Ayrburn Screen Hub - South Neighbours Additional Mitigation Plan
10 February 2026

Ayrburn - Studio and Visitor Accommodation Design Report 11 February 2026

Figure 2: Effect of gap in noise barrier

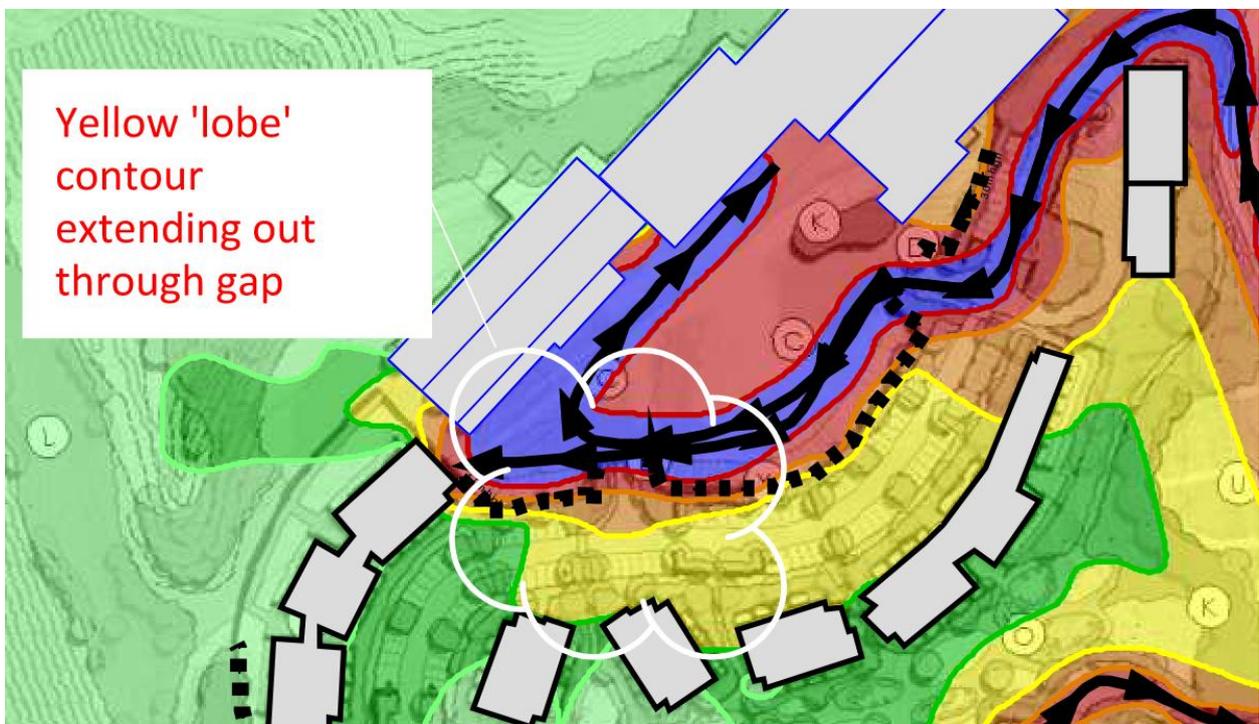
The two gaps in the 2.4m noise barrier would reduce performance in a localised area. However, this would be experienced internal to the site and would have an inconsequential effect on any neighbouring receivers.

Noise barriers are maximally effective when the source or receivers are close to the noise barrier. The neighbouring receivers are more than 100m from the closest gap.

The effect of the two gaps can be seen in the Noise Contour Maps at Appendix C in the Supplementary Noise Assessment memo dated 20 January 2026. The effect is a 'lobe' of noise that extends out through the gaps – see below extracted from the Supplementary Noise Memo.

The 2.4m high acoustic barrier around the backlot is not required for noise mitigation of site noise from the Screen Hub to external neighbours. Please refer to Appendix F of the Acoustic Assessment Report³ which shows that compliance was readily achieved without this 2.4m acoustic barrier being included in the modelling.

The acoustic barrier around the backlot was included for internal site acoustic amenity and privacy separation between the two activities.
